**George Air Force Base, California**

**Installation Restoration Program**

**Record of Decision  
Operable Unit 1**

March 1994

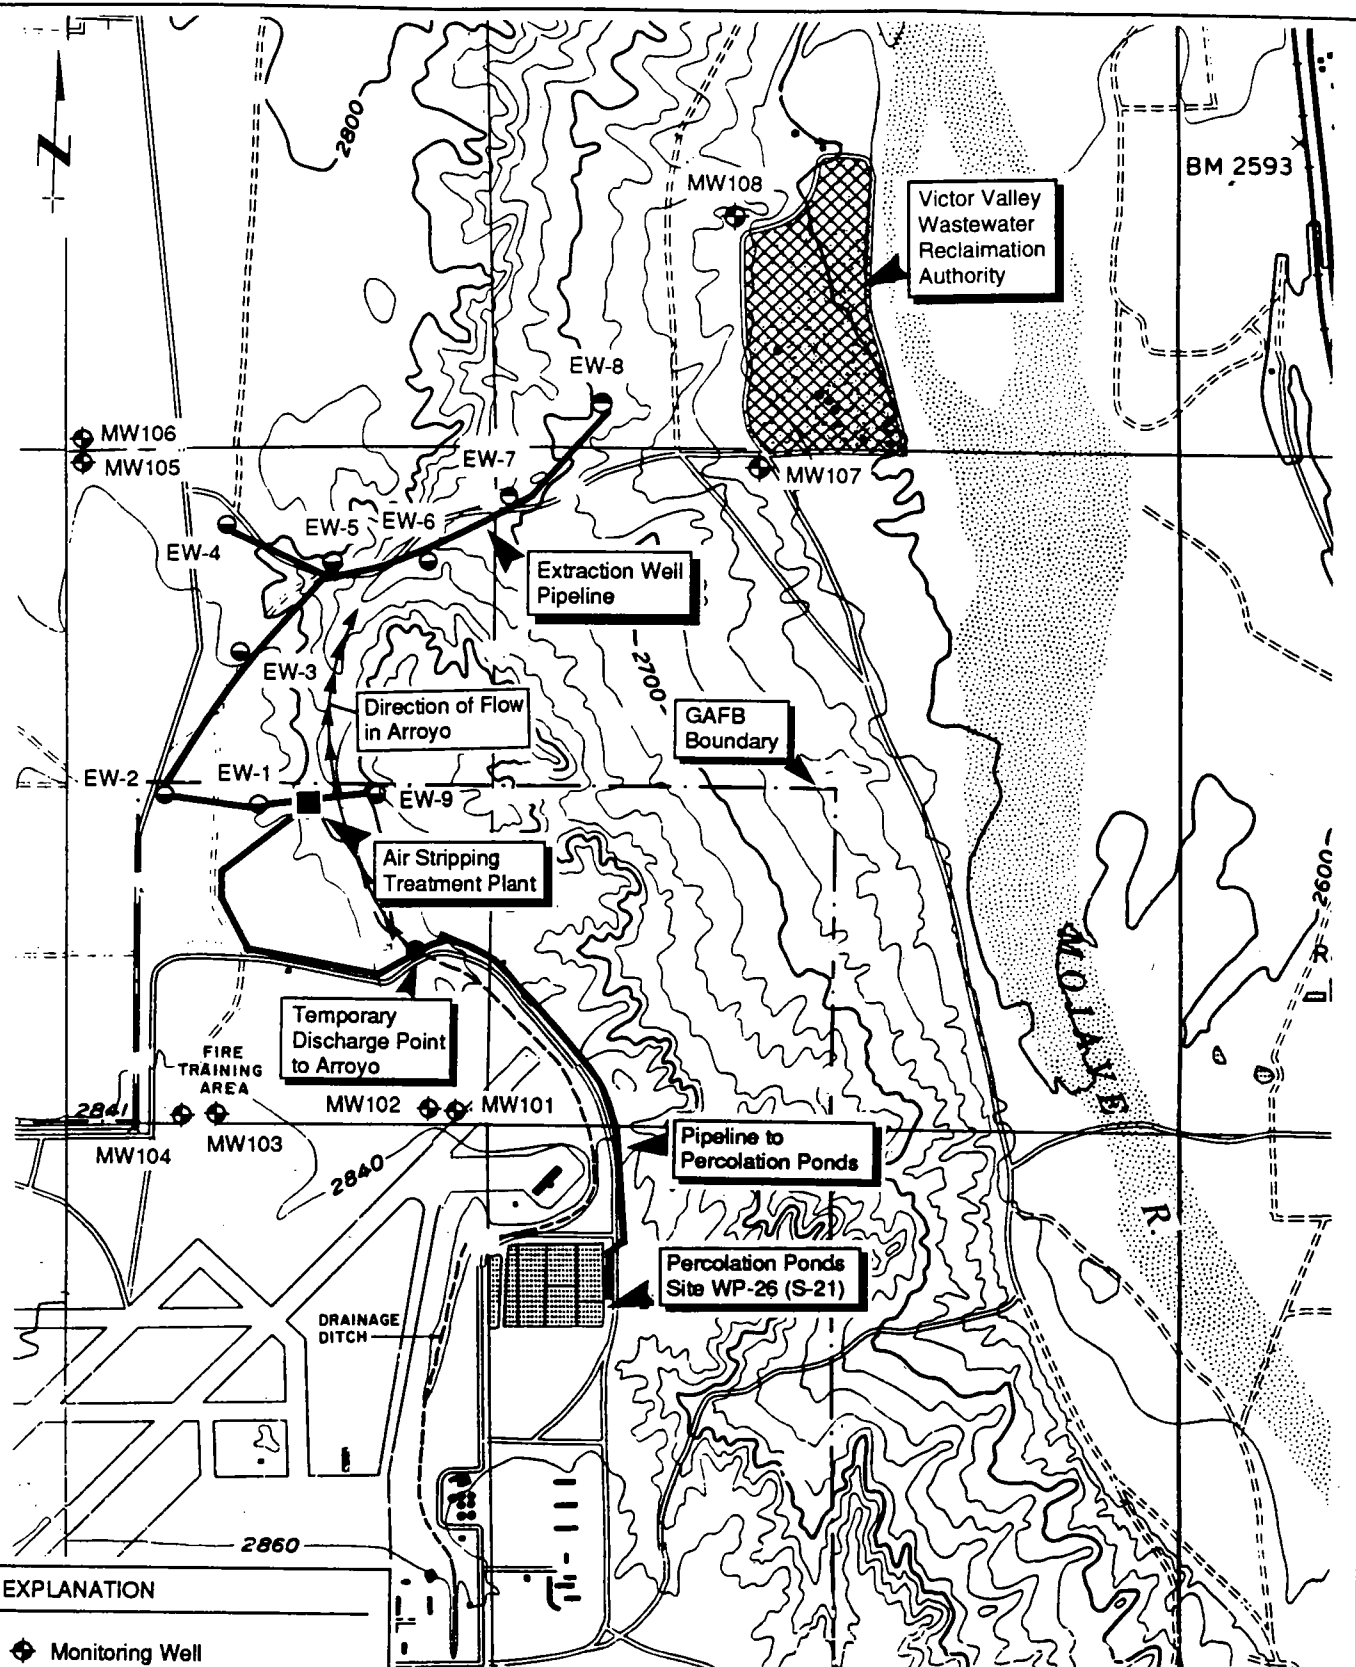
4. Figure 8, Distribution of TCE in Groundwater

- b. 2nd paragraph, Figure 8 does not show where the two aquifers merge as indicated.
- c. 2nd paragraph, Please delete or reword the last sentence in this paragraph; "Contamination at this location currently does not pose an immediate threat to any potential receptor". This is in conflict with the State's policy to view ground water as a resource to protect, preserve and restore for present and potential future users, rather than a pathway of potential exposure to existing

5. **Distribution of TCE in Groundwater at 5 ppb, Figure 8**

4. Figure 8

a. Although Figure 8 is included to present the data that was available when the 1988 FS analysis was performed, an additional figure (Figure 11) has been added to the document to present the most recent information regarding TCE distribution in the groundwater. The title of Figure 8 has been revised to clarify that it presents 1987 data.

c. See response to Comment 4 (a) above. Only the wells available during the 1987 sampling events are presented on this figure; however, the wells around the percolation ponds are presented on Figure 11.

b. Figure 8 has been revised to show the approximate location of the lateral edge of the Upper Aquifer.

5. Figure 8

The approximate location of the lateral edge of the Upper Aquifer has been added to the figure. A distinction has been made between wells screened in Upper and Regional Aquifers. The intent of this section, and this ROD, is to summarize the conclusions of the 1992 RI and 1993 FS reports which summarized previous work (i.e., 1988 RI/FS) and were based on previous data. As indicated in the legend of Figure 8, the plume presented is based on 1987 data. Presentation of current data in Figure 8 would be misleading. However, Section 2.12 has been added to the text of this ROD which summarizes activities which have occurred to date as well as the scope of the ongoing Investigation in Support of RD/RA which includes installation of 12 wells to address the data gaps to the north and northeast. Figure 11 has been included in this Section 2.12 which presents the most recent groundwater sampling results in light of recent activities.

**CONCEPTUAL DESIGN OF PHASE I  
OF THE EXTRACTION AND MONITORING  
WELL SYSTEMS  
ALTERNATIVES 2 AND 3**

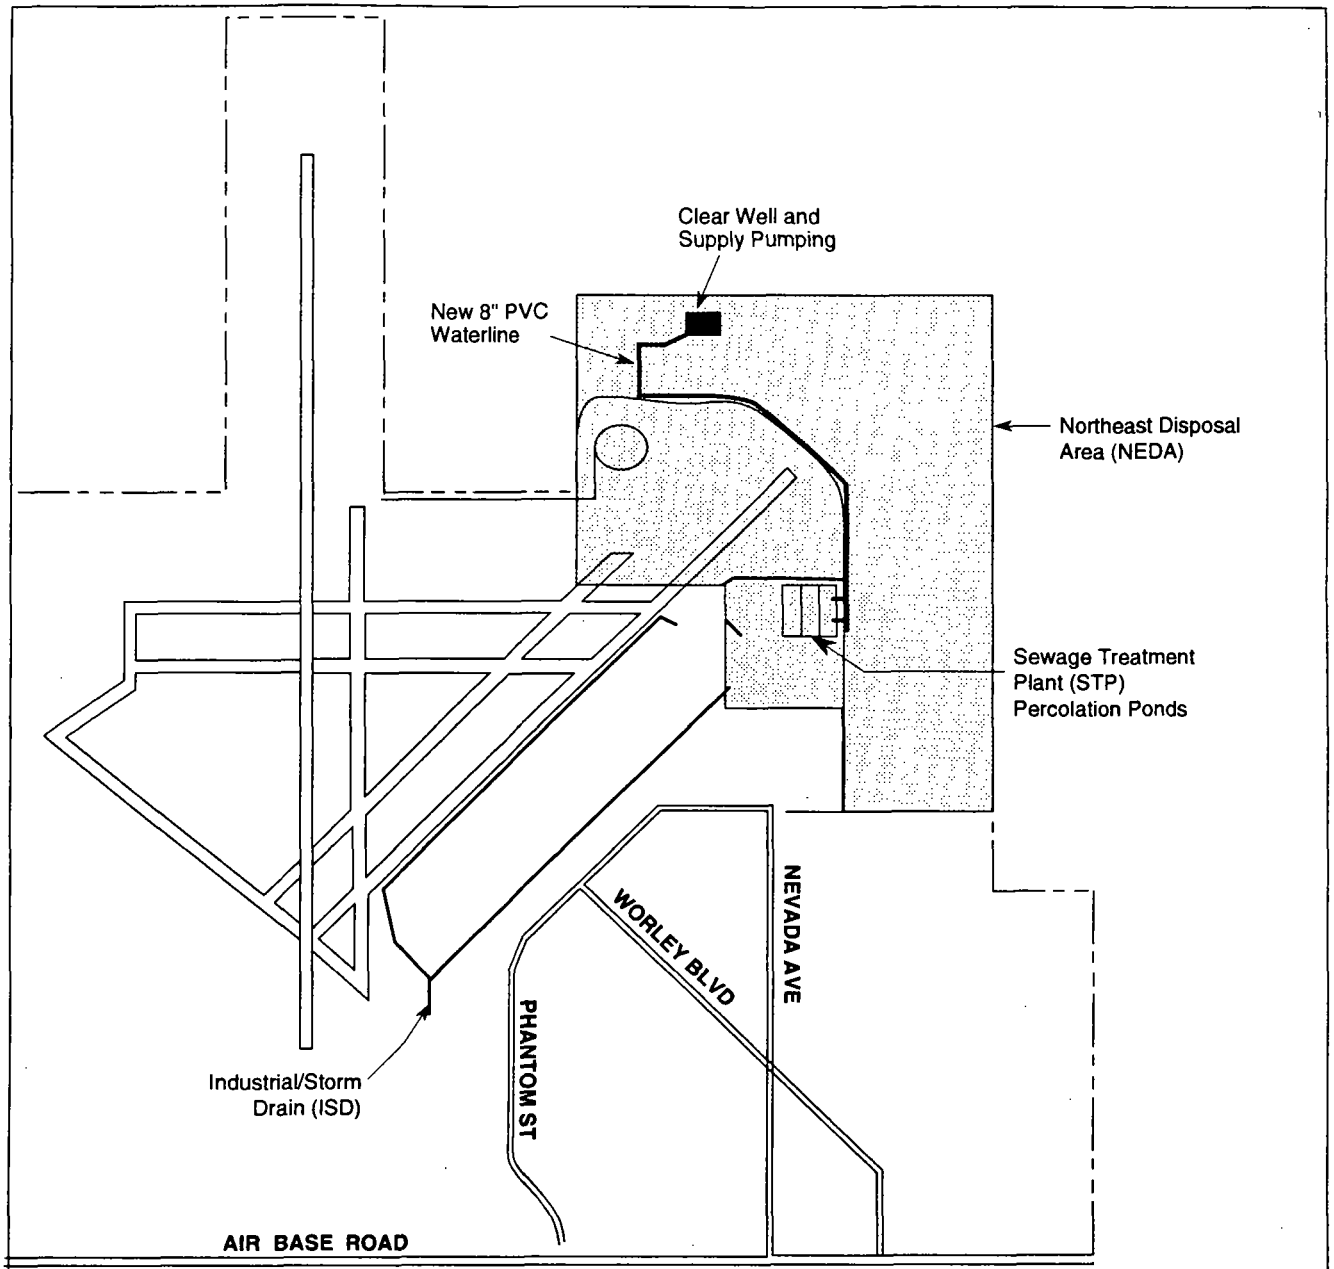
11. Figure 9, Conceptual Design of Extraction and Monitoring Wells

This figure is misleading. It should be revised to note what facilities are completed as part of Phase I and what facilities are proposed (or necessary) for Phase II. To better illustrate the proposed remedy, we suggest another figure be included to show all proposed Phase II well locations (see final FS, Figure 5-1). The figure should clearly indicate that the locations may be modified as necessary to maximize plume containment and capture, based upon a future capture zone analysis and review of Phase I treatability study data.

3. Figure 9, add to Title box:

11. Figure 9

1. The text has been modified to state that the wells "were, but are not currently used for potable water."
2. The text has been modified accordingly.
3. The title of Figure 9 has been modified to clarify that it shows Phase I of the extraction/treatment system. The text now states that because the exact number and location of extraction wells for Phase II is pending determination of Phase I efficiency, they are not shown on Figure 9.

This paragraph is misleading. Most of the components referred to as part of Phase I are installed now. Temporary discharge has occurred to the arroyo since December 1991, about two years. The text should describe the operating system realistically. Definite dates for submittal of the Phase II work plans should be included. The last sentence indicates that proposed locations of Phase I components are shown on Figure 10. The components shown on Figure 10 are existing, not proposed.
